Remedy available for  
 2024 (WL) Jeep Grand Cherokee/Grand Cherokee L

**SAFETY RECALL**  
NORTH AMERICA  
**Speedometer Lag**

Reference: B8B / NHTSA 24V-872

**Figure 1 – Check for Car Graphic (with sales code XH3)**

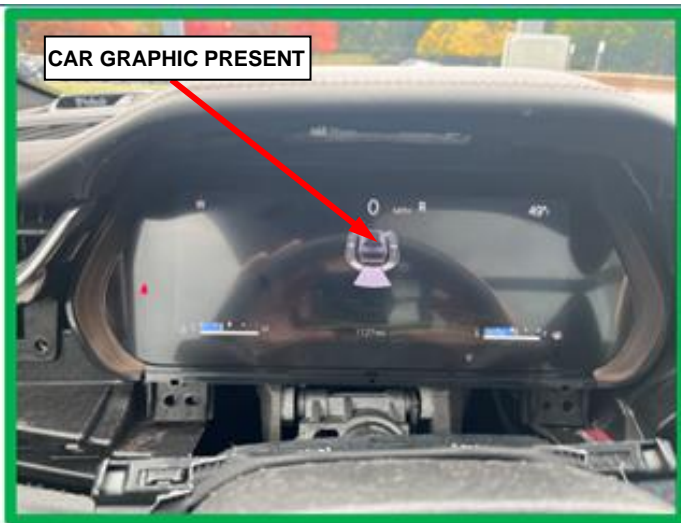
1. Start the vehicle.
2. Move the shifter position to Reverse.
3. Check for cluster graphics in Park Sense Rear Braking Assist screen (Figures 1 and 2).

- 
4. Does the car graphic appear (Figure 1 and 2)?
    - YES>>> This vehicle has passed the inspection and may be returned to the customer. Claim the inspect LOP to close the recall.
    - NO >>> Proceed to Step 5.
  5. Reload the software to the IPC. See B, IPC Update.
